Re: Albert Frei & Sons, Inc.; Walstrum Quarry; File No. M-1983-033; Amendment Application (AM-09); Geotechnical Review Memo

RE: Walstrum Quarry AM-09, DRMS File No. M-1983-033
Slope Stability Review

Galena Slope Stability Results

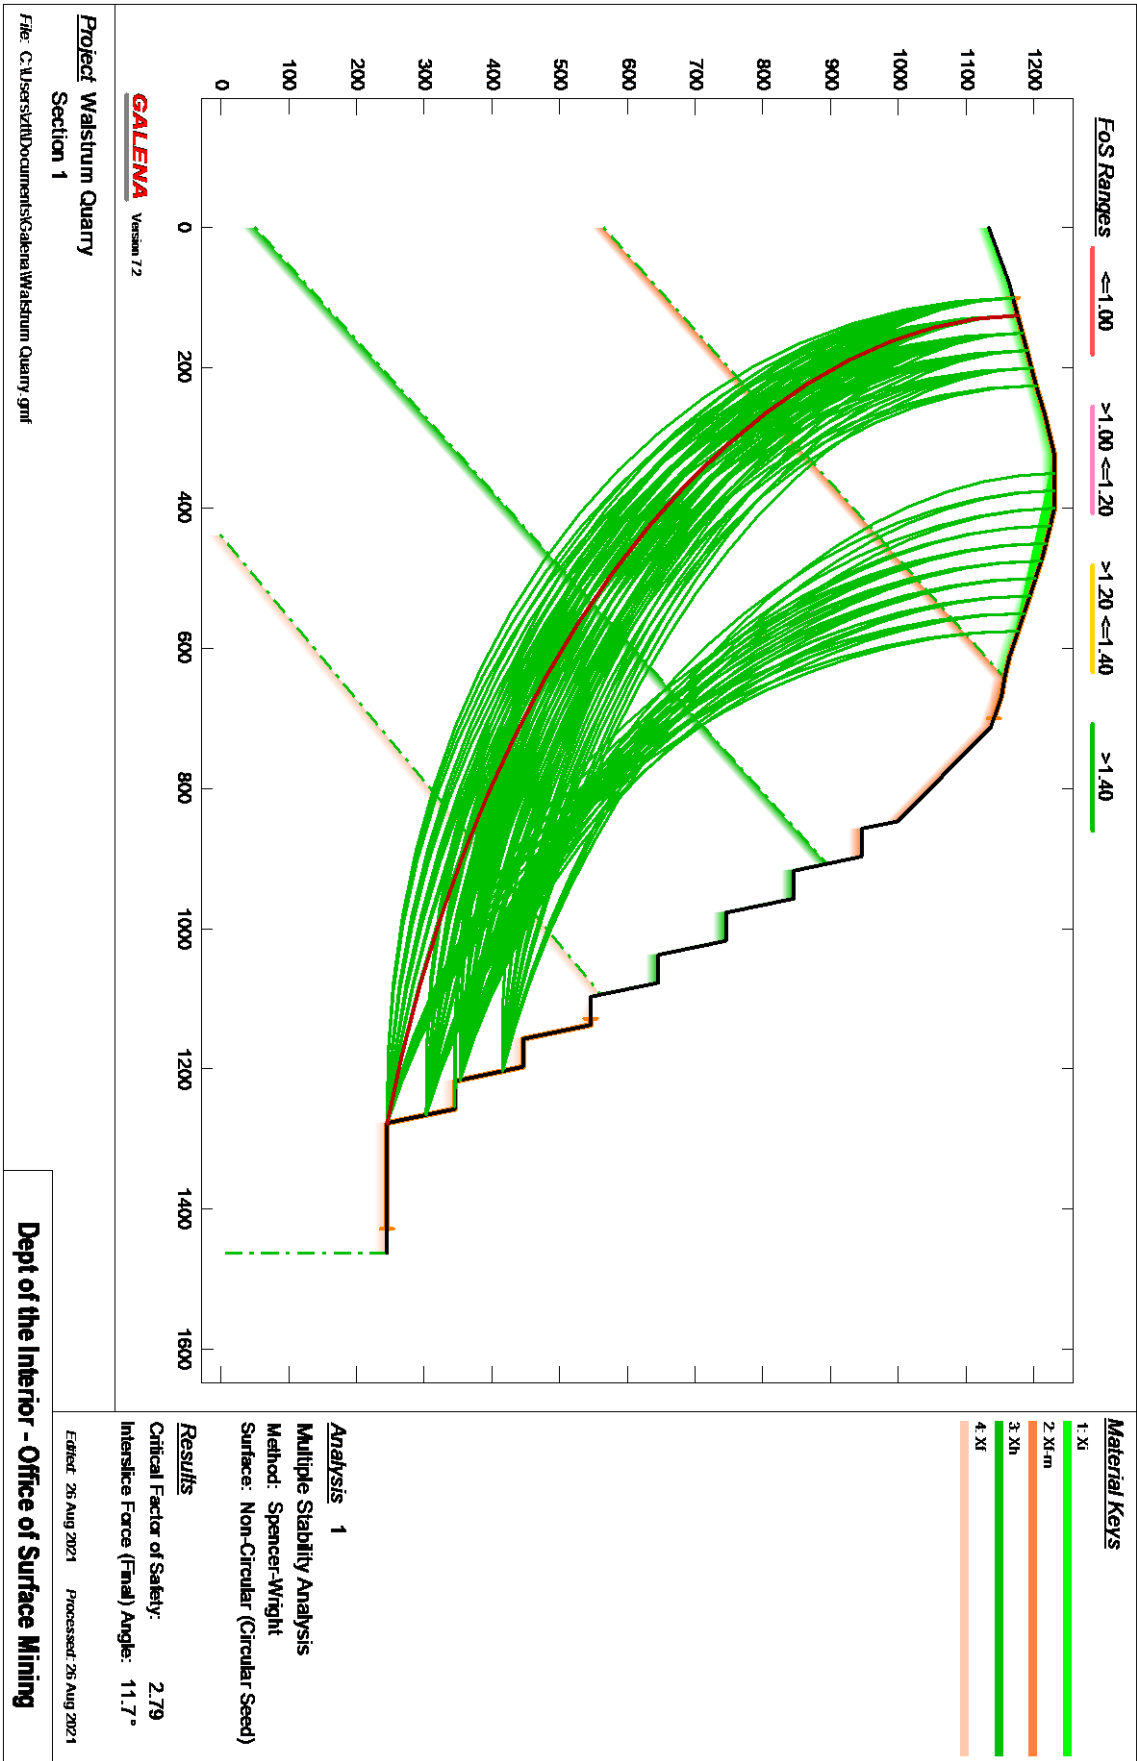
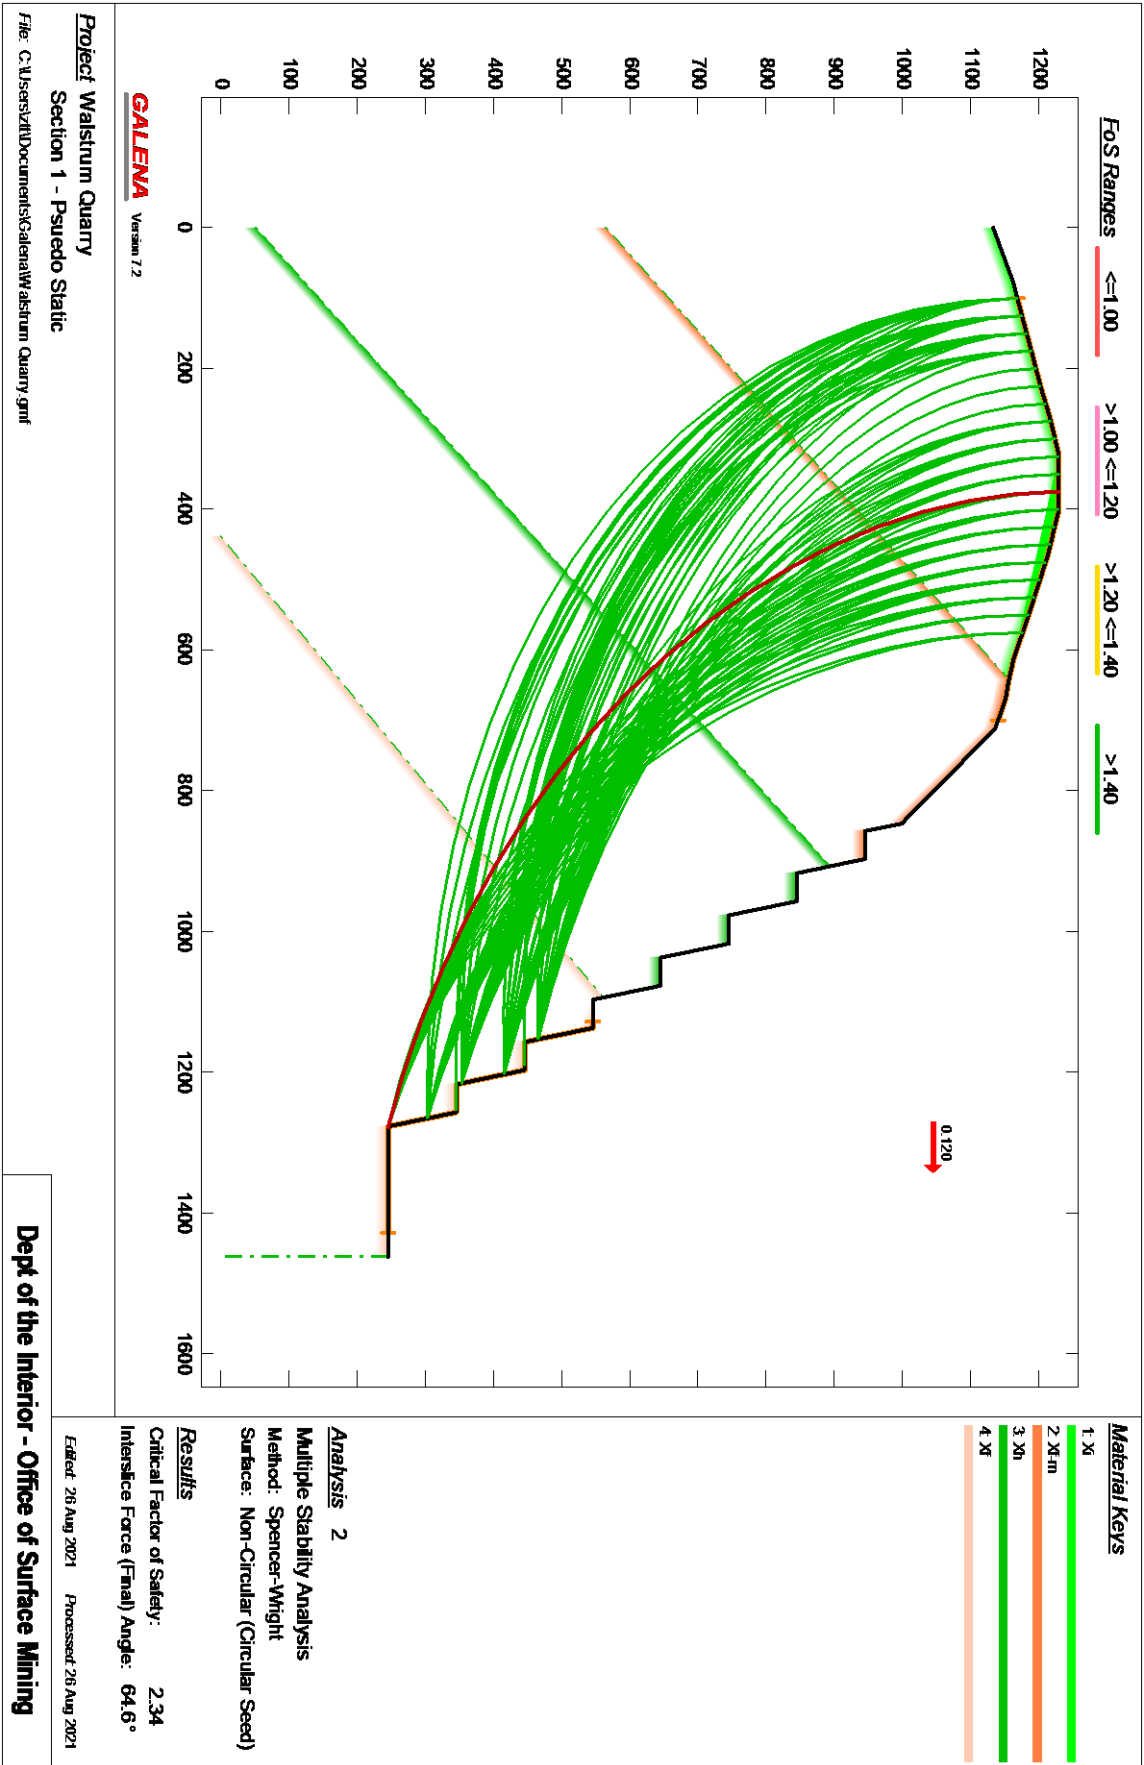
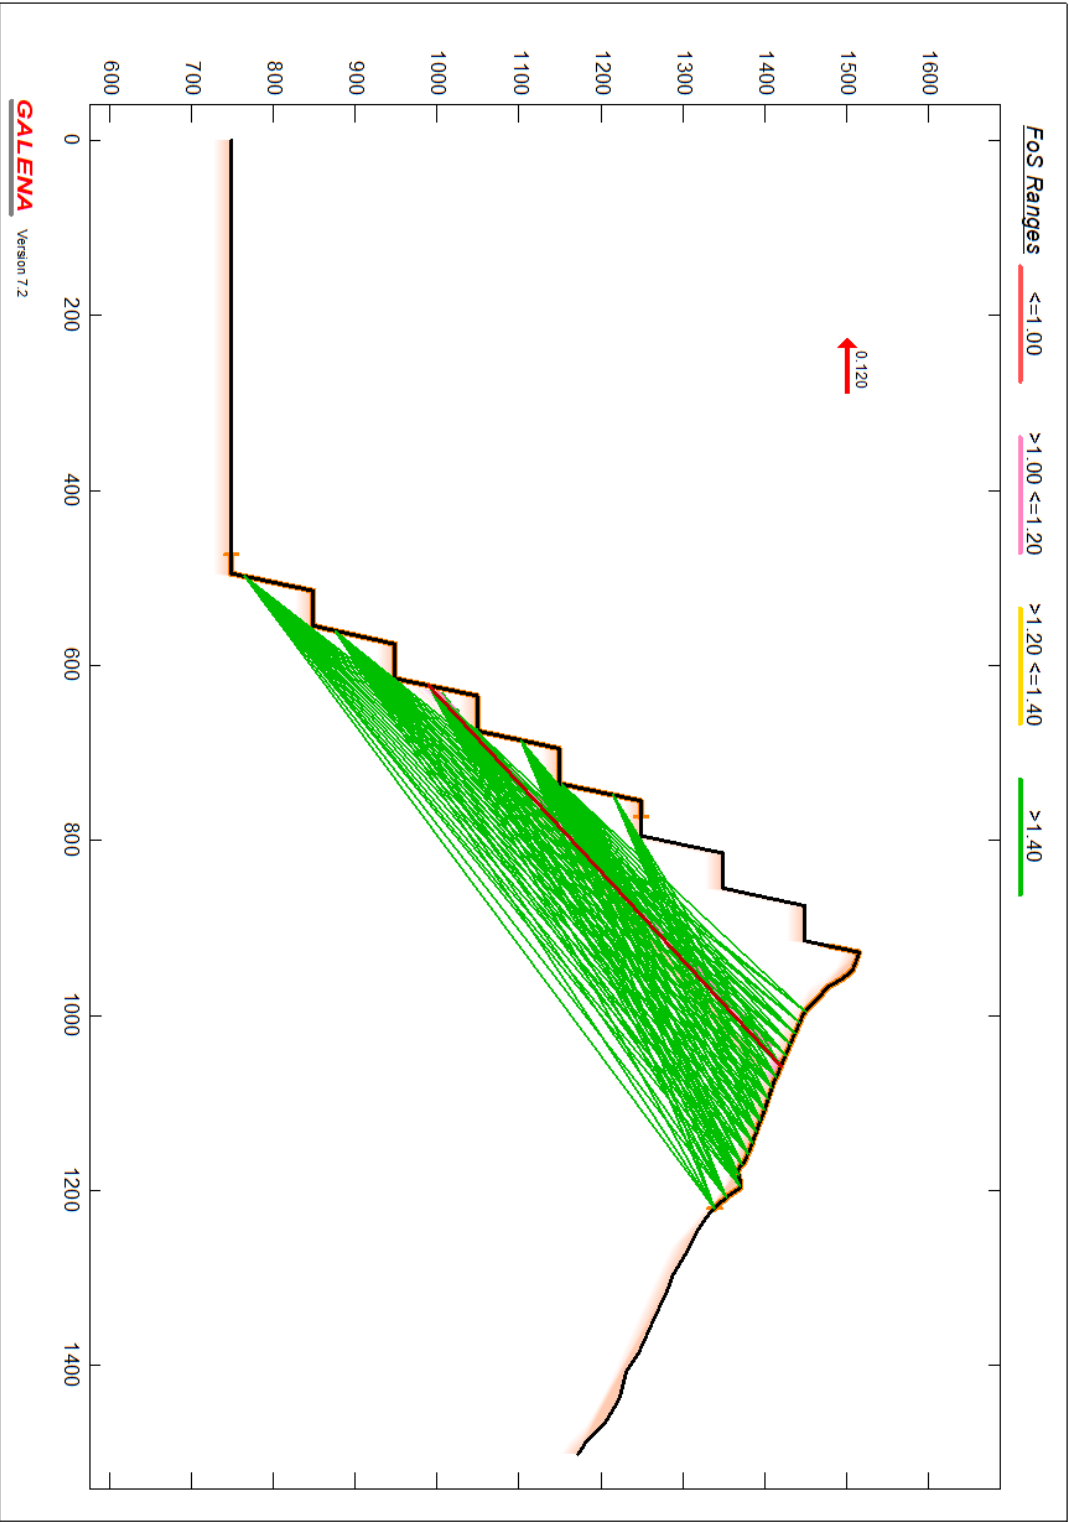
After reviewing the Exhibit, the Division performed a slope stability check along Section 1 and Section 2 under static and pseudo-static conditions using the slope stability software, GALENA. At the request of the Division, Walstrum provided supplemental information which included AutoCAD files for the slope profiles for Section 1 and 2.

The Division reconstructed the slope profile for both sections based on supplemental information provided by Walstrum. Using the material properties provided within the Exhibit, slope stability checks were performed under static and pseudo-static conditions. In addition, the sensitivity analysis was also checked for the 10-foot-thick layer of low strength rock midway down slope at a 45 degree angle under seismic conditions. The resulting factors of safety are summarized below in comparison to the results provided by Walstrum and the requirements of the Division.

As shown by the above table, the Division’s resulting factors of safety are higher or closely resemble that of Walstrum’s results outside of the sensitivity analysis. The factor of safety calculated by the Division for the sensitivity analysis is lower than what was produced by Walstrum and is below the minimum requirements of Section 30 for pseudo-static conditions.

Section 2 sensitive analysis model profile without results.

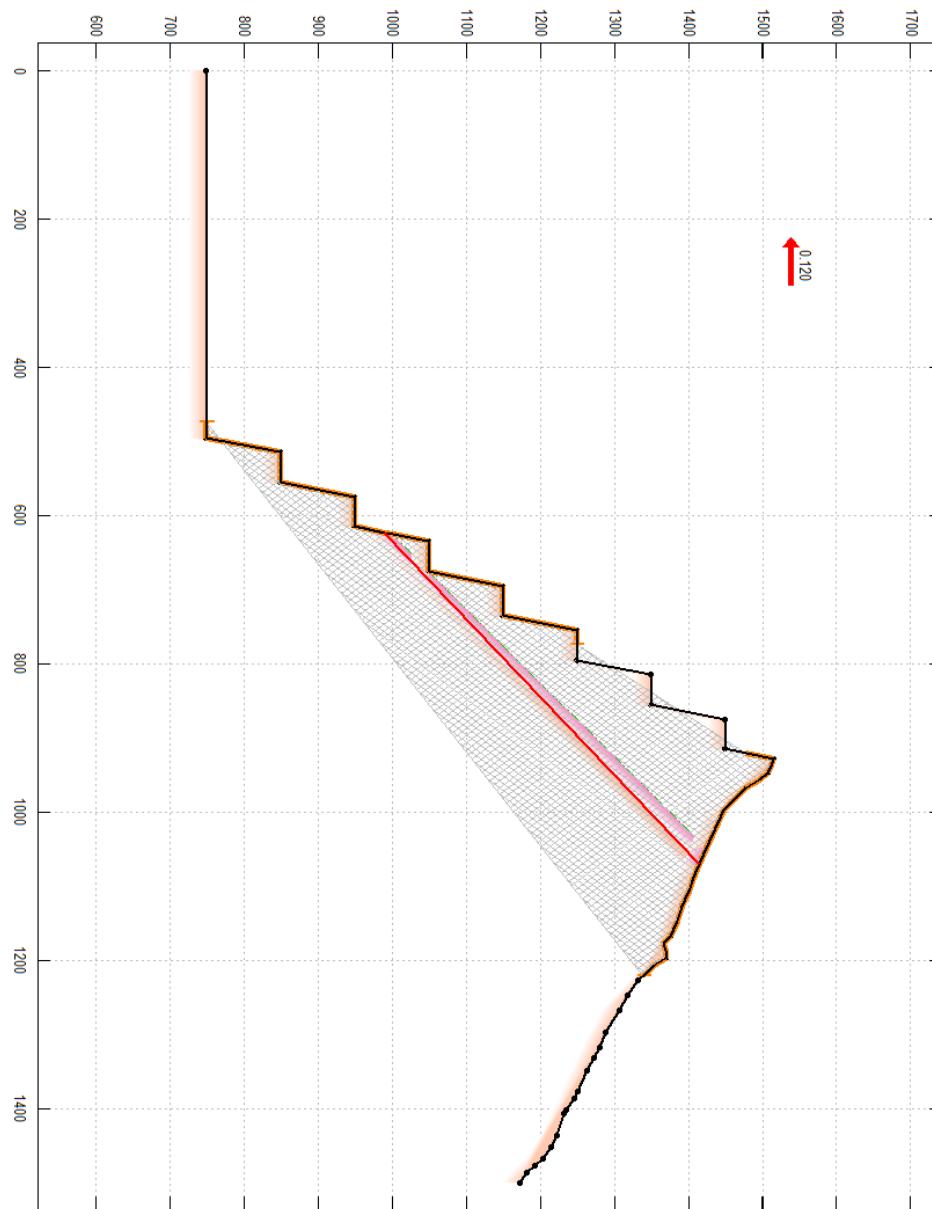
When comparing the Division’s slope profile to that of the provided profiles with the supplemental information, it appears that the angle of slope used for the low strength rock do not match. Using a 45 degree angle for the low strength rock, the Division’s slope profile appears to be angled steeper than that which was provided with the supplemental information. When measuring the provided slope angles within AutoCAD, the maximum angle discovered was 40 degrees. This difference in a higher angle would result in the lower factor of safety as observed with the Division’s results for the sensitivity

analysis. This leads the Division to believe that perhaps there is a typo in Table 5 within the Exhibit and a lesser angle of slope was used for the sensitivity analysis to result in a factor of safety of 1.15 under pseudo-static conditions.

- **Please have Walstrum confirm the angle used for the low strength rock in the sensitivity analyses that result in the factors of safety provided in Table 5 of the Exhibit.**
